**Sub-Committee of Experts on the Transport of
Dangerous Goods**

Item 3 of the provisional agenda

**Information on document ST/SG/AC.10/C.3/2020/18
“Modifications concerning Salvage Pressure Receptacles”**

Transmitted by the expert from Germany

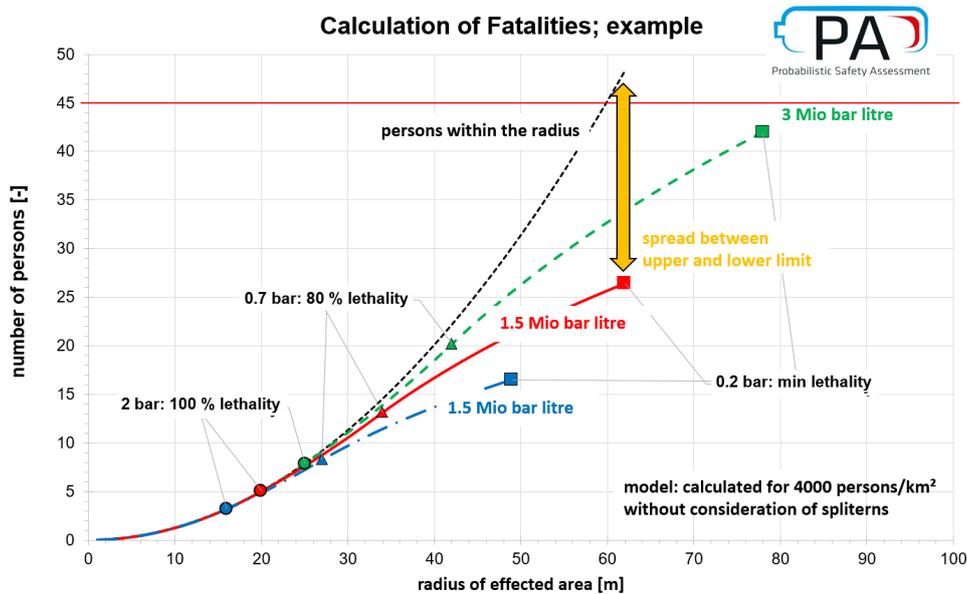
9. **Comment:** We prefer to consider this proposal after the publication of ISO 11515.

The blow over of persons and damages of some glass windows are used to approximate the number of possibly injured persons, and for fatalities the lower limit is used. Knowing that there is a variation in model approximation of blast waves, guiding values are illustrated for different gases in the following figure. The influence of gas properties is significant. Here the common calculation of an TNT-equivalent has not been used. It overestimates the consequences.

The consequence of a worst-case scenario and therefore the criteria to call it a catastrophe depends largely on the population density and its lethality due to pressure waves. Higher pressure volume products result in higher overpressures and a larger risk area. The higher overpressures cause a higher lethality in the near field of the accident. As secondary consequences, e.g. splinters from the pressure receptacle itself or from impacted buildings, are not part in this analysis of fatalities. Those fatality lines are lower boundaries. The upper boundary is the total number of people inside the risk area. Both is shown in the figure below. The spread (big arrow) indicates the possible size of the catastrophe for the proposed 1.5 Mio bar litre. A population density of 4000 people/km² is chosen for the following figure. This density represents the average density in Berlin, which stands for a big city with a lot of forest and water areas. Most cities will have a (much) high population density with an adequate higher consequence.

In conclusion, for average gas properties and an average city population density a value of 1.5 million bar litre for the product of test pressure times water capacity is appropriate to limit the size of consequences in terms of fatalities to 45 in general. As some gases may cause worse consequences, an additional limit for those gases will be proposed to amend packing instruction P200.
